City of Sacramento City Council

Meeting Date: 11/8/2012

Title: Freeport Boulevard Bike Lanes Project

LIST OF AGENCIES AND PERSONS PROVIDING COMMENTS ON THE DRAFT ENVIRONMENTAL IMPACT REPORT

PROPOSED PROJECT OPTION 2 (PP2) FREEPORT BOULEVARD TYPICAL SECTION 13TH AVENUE TO BIDWELL WAY

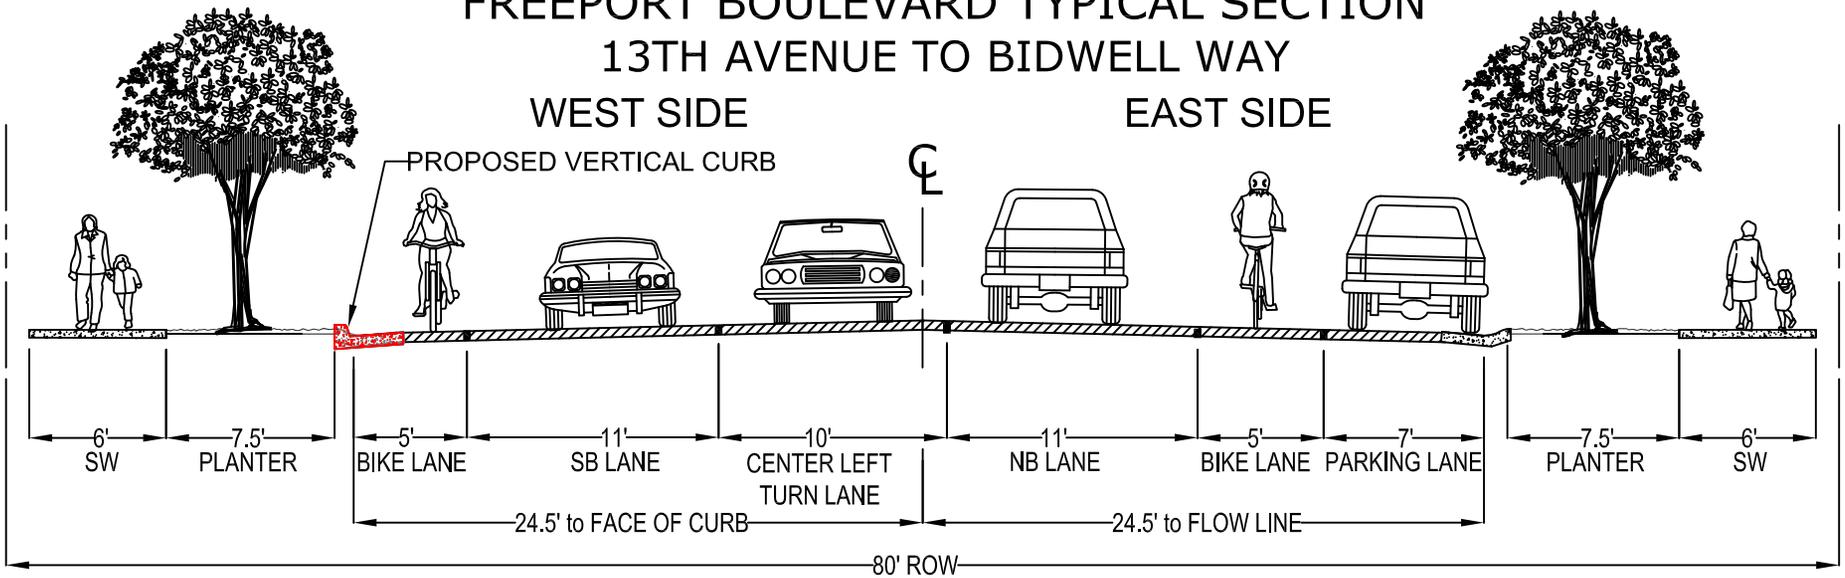
We request several adjustments to the specifications for PP2 as shown in Figure 2.5:

□ The new gutter pan constructed with the new west side vertical curb should be reduced in width so that the seam between the pavement and the gutter pan is not in the middle of the bike lane. Figure 2.5 shows the gutter pan extending halfway across the 5 ft. wide bike lane. The portion of the bike lane not including the gutter pan should be at least 3 ft. wide (Caltrans Highway Design Manual Chapter 300).

□ The east-side bike lane next to the parking lane should be enlarged to a 6 ft. width instead of the 5 ft. shown in Figure 2.5 because of the hazard of vehicle doors being opened in front of bike riders and causing the riders to swerve into the adjacent traffic lane or to crash into the vehicle door. We believe the additional 1 ft. of width can be found by slightly reducing vehicle lane widths by several inches each or by pushing the new vertical curb on the west-side of Freeport several inches further west.

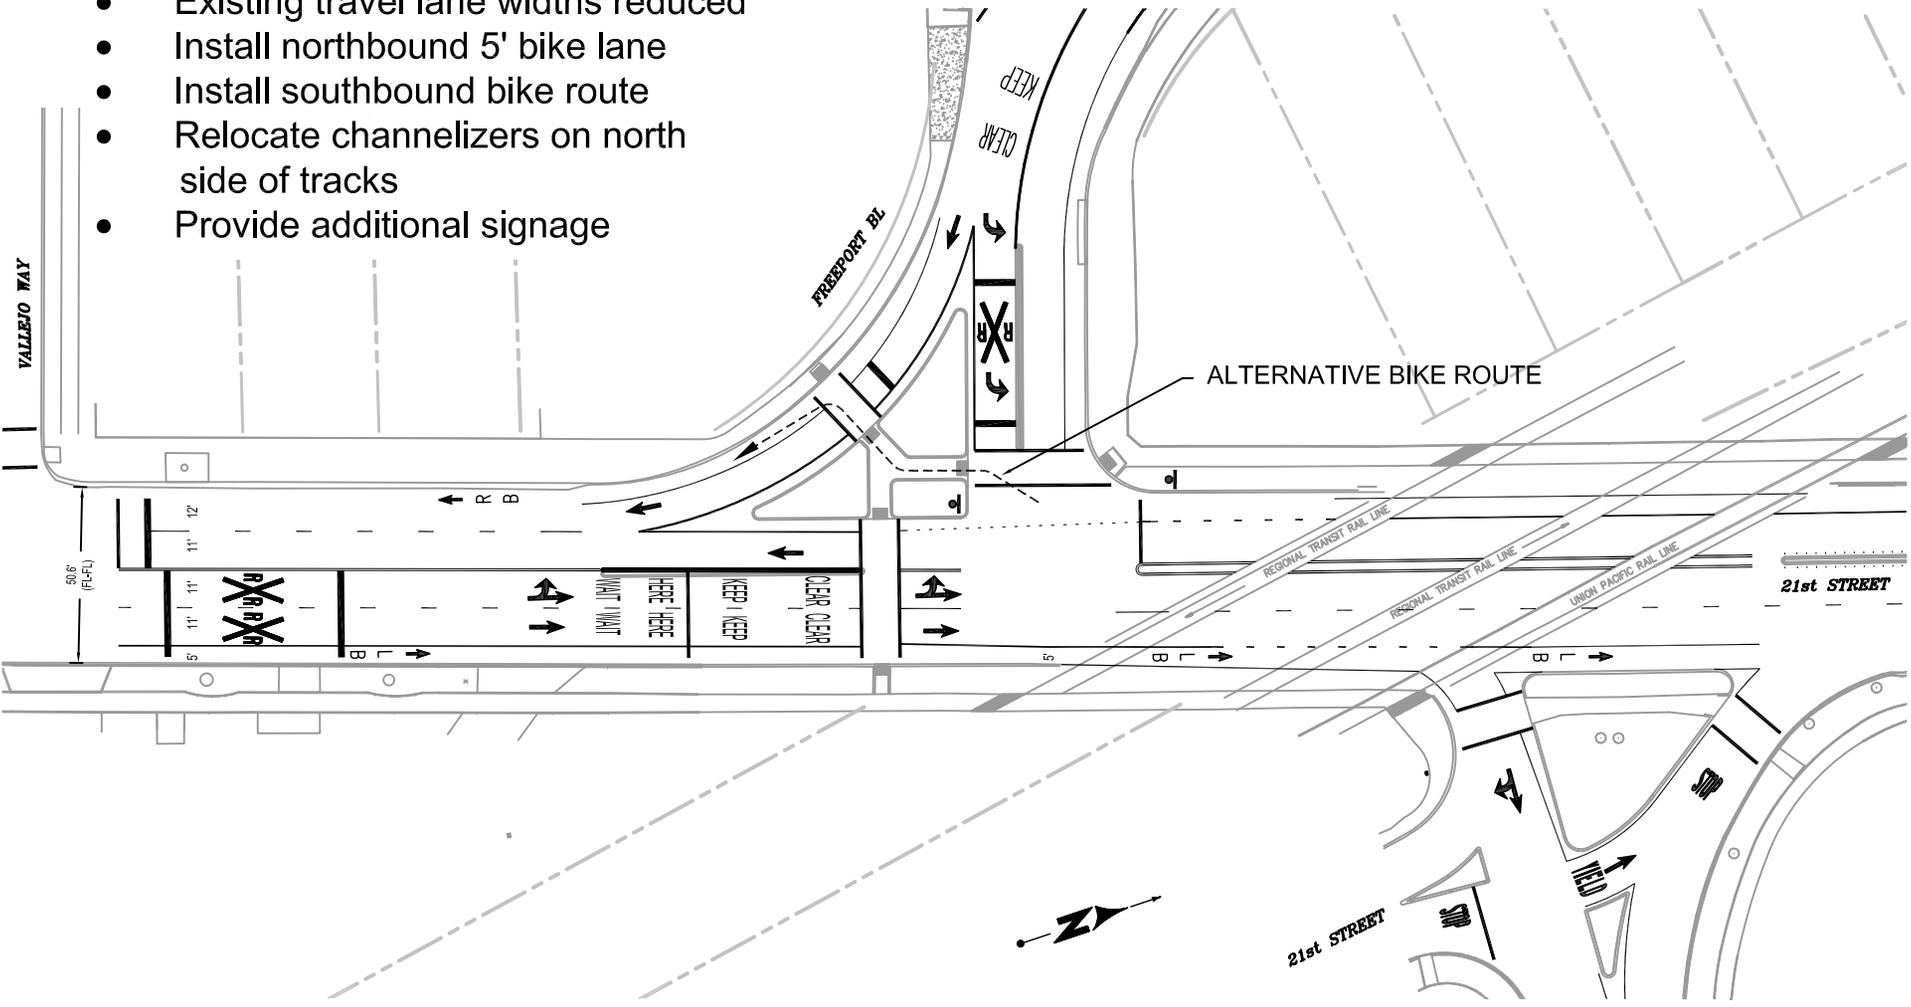
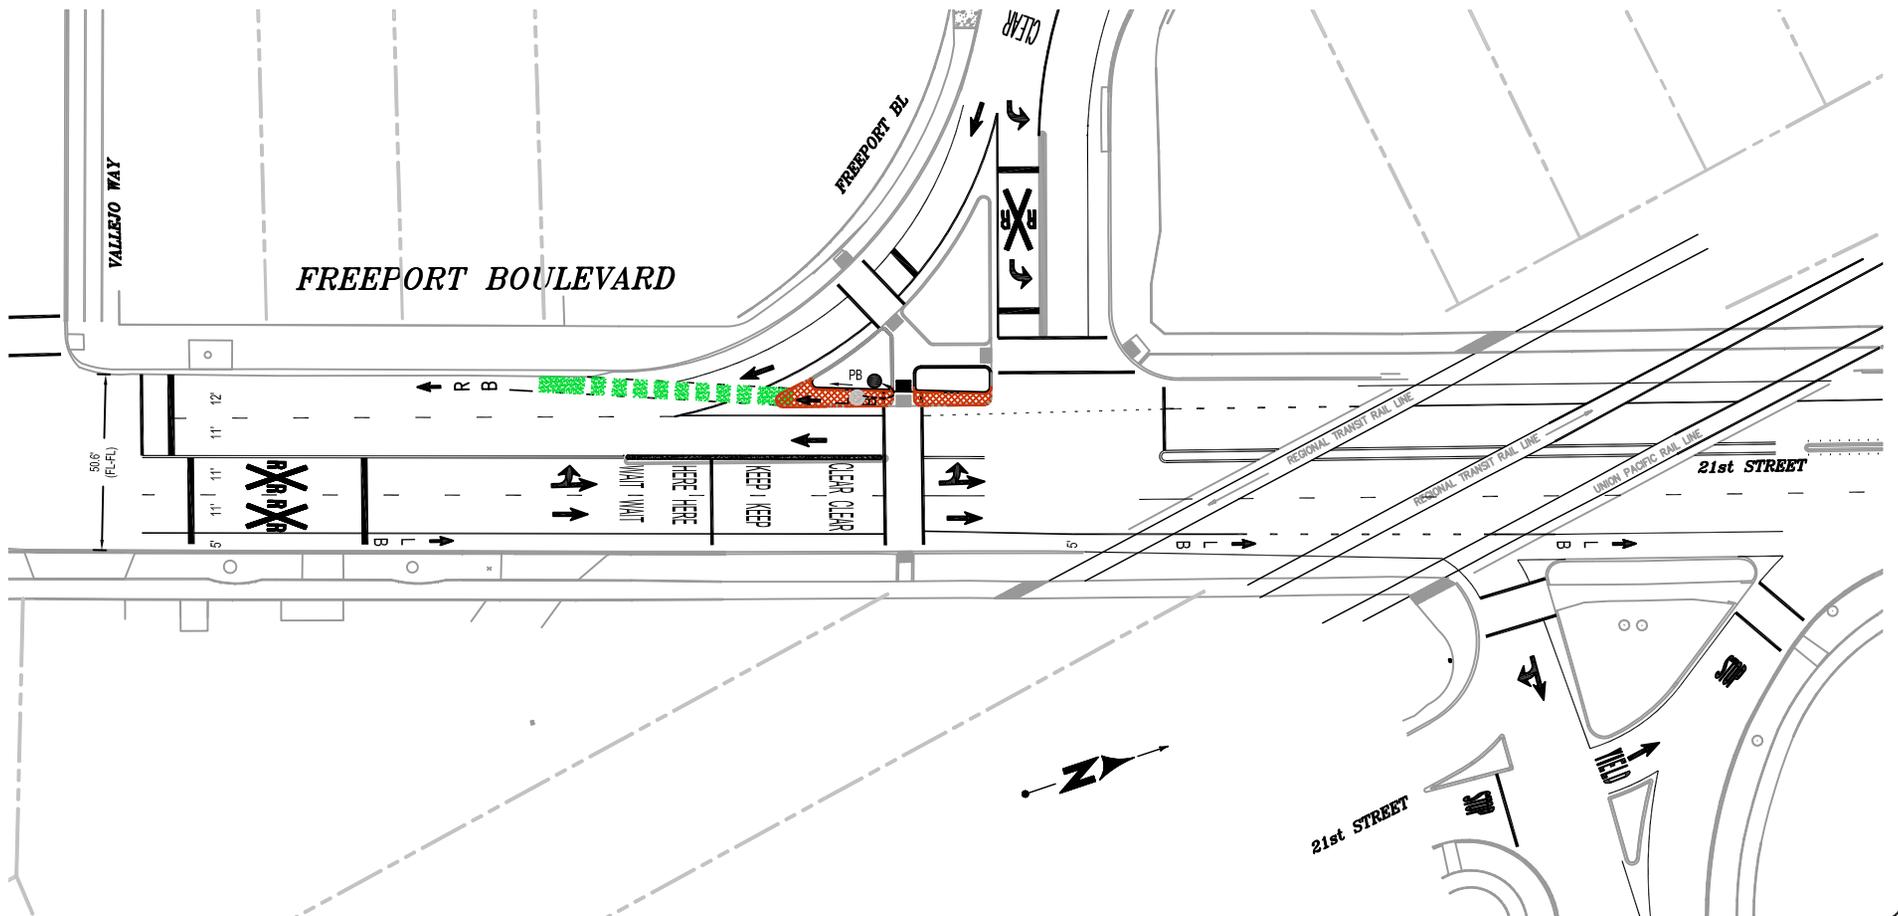
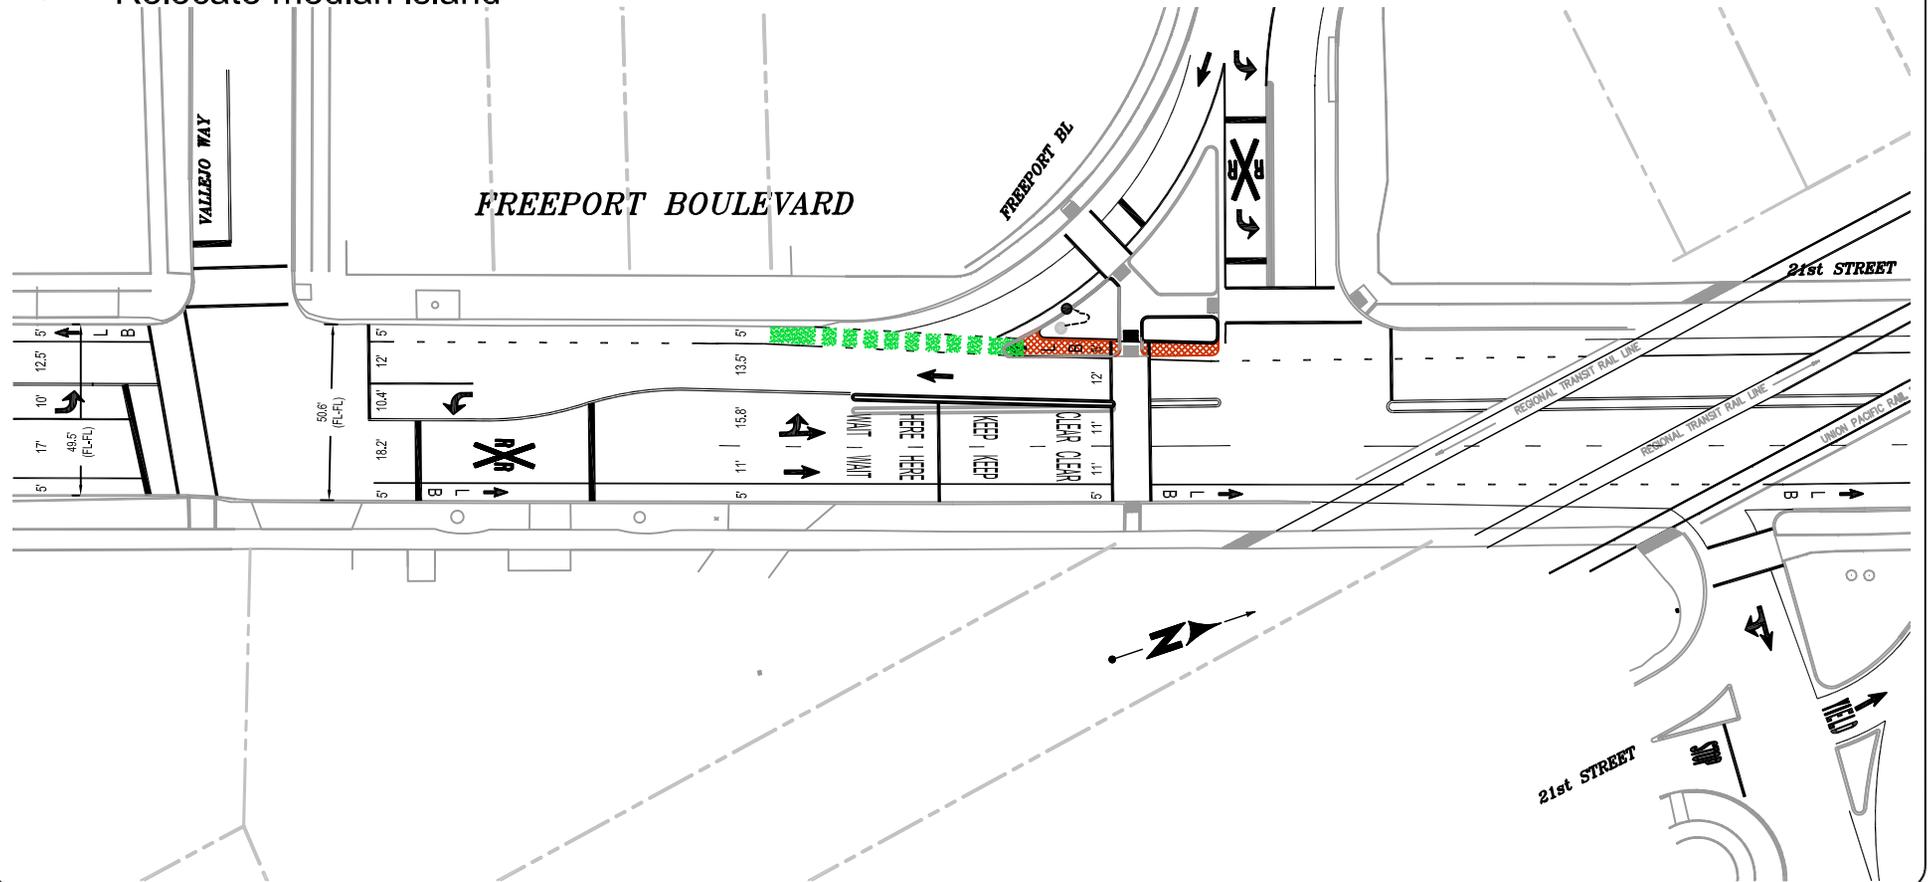
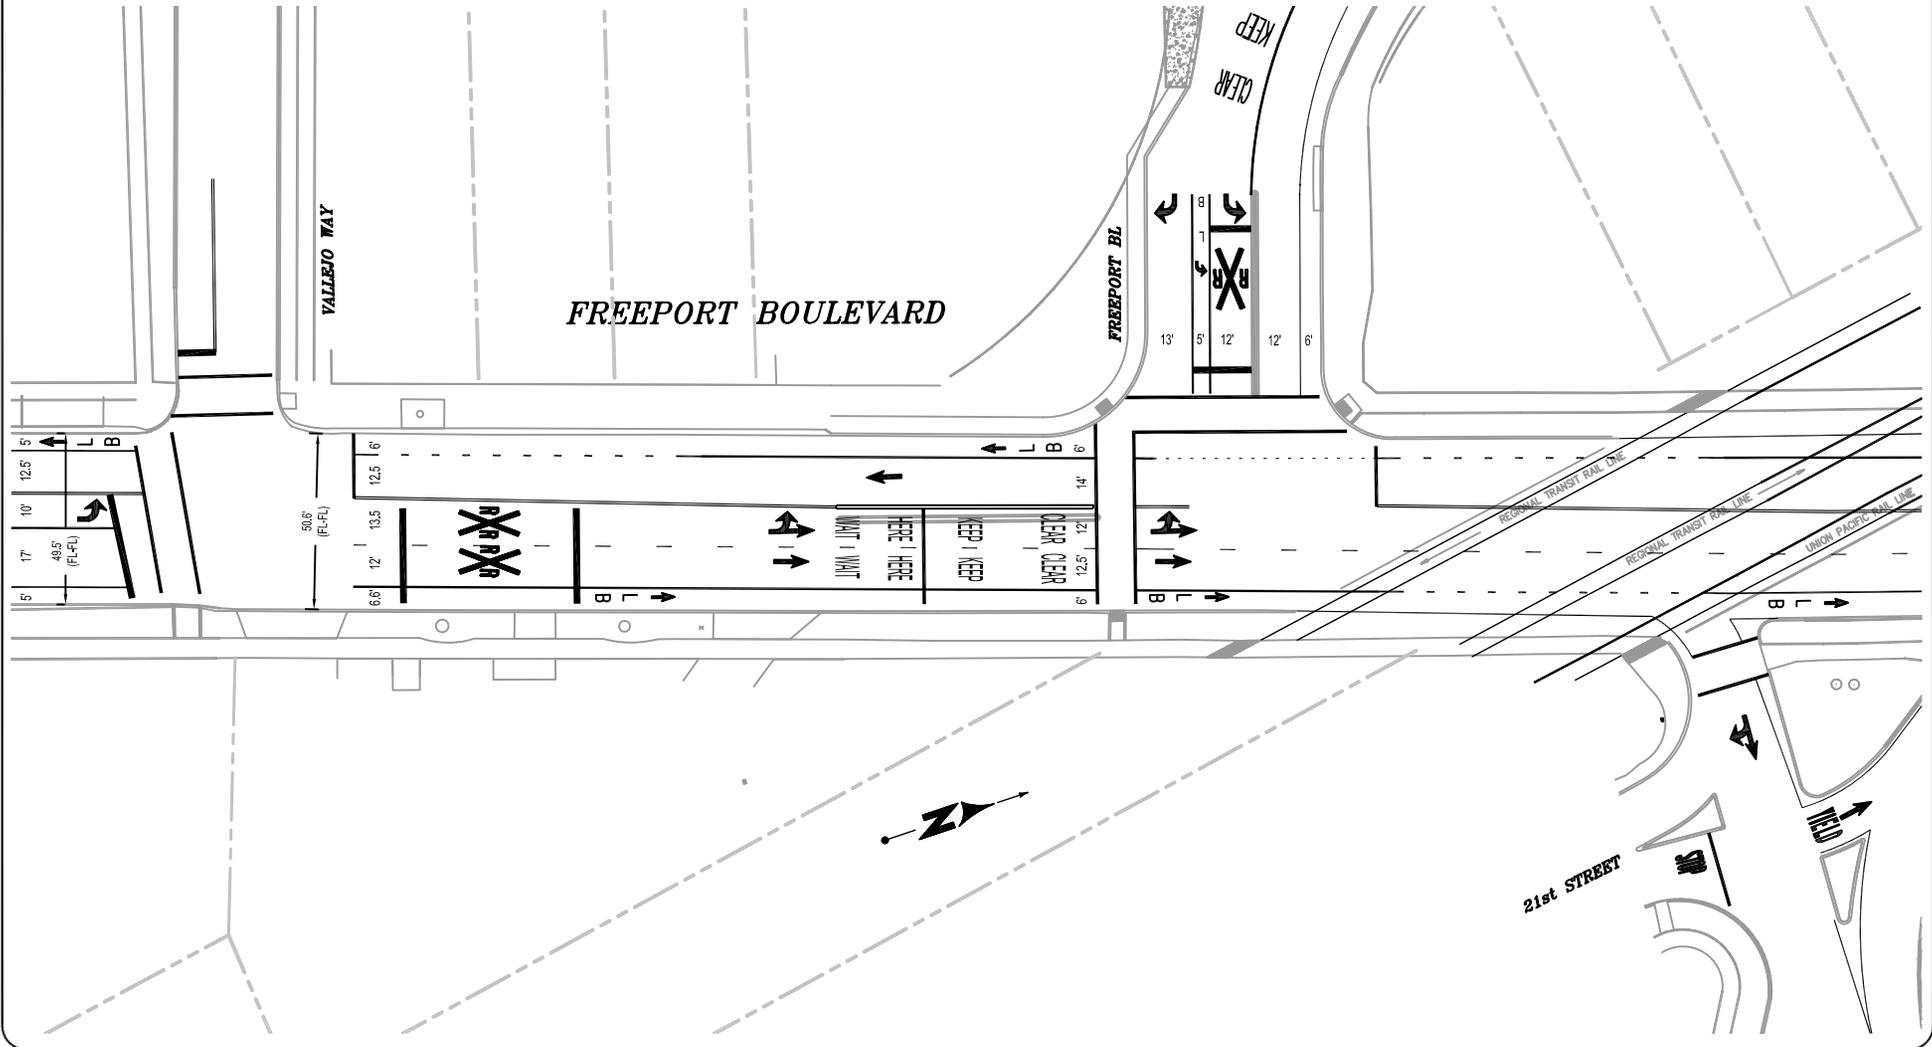
Figures 2.7 through 2.10 depict the four design concepts for the Freeport/21st St intersection. All of these figures show that Freeport would have double traffic lanes northbound from Vallejo across the UPRR tracks and onto 21st St at 4th Avenue. We believe that these double lanes will tempt vehicle operators to try to pass slower vehicles, assuming no vehicles are using the left lane to make a left turn into Freeport Blvd. Such passing movements would be extremely hazardous to pedestrians and bicyclists, as local residents have observed many times: the increased vehicle speeds required to pass would combine with poor visibility of conditions on 21st St caused by the elevated railroad tracks and the sudden merger of the 2 traffic lanes to one on 21st St immediately north of the tracks. To solve this hazardous situation, the temptation to engage in high speed passing movements should be prevented. Therefore, we request that
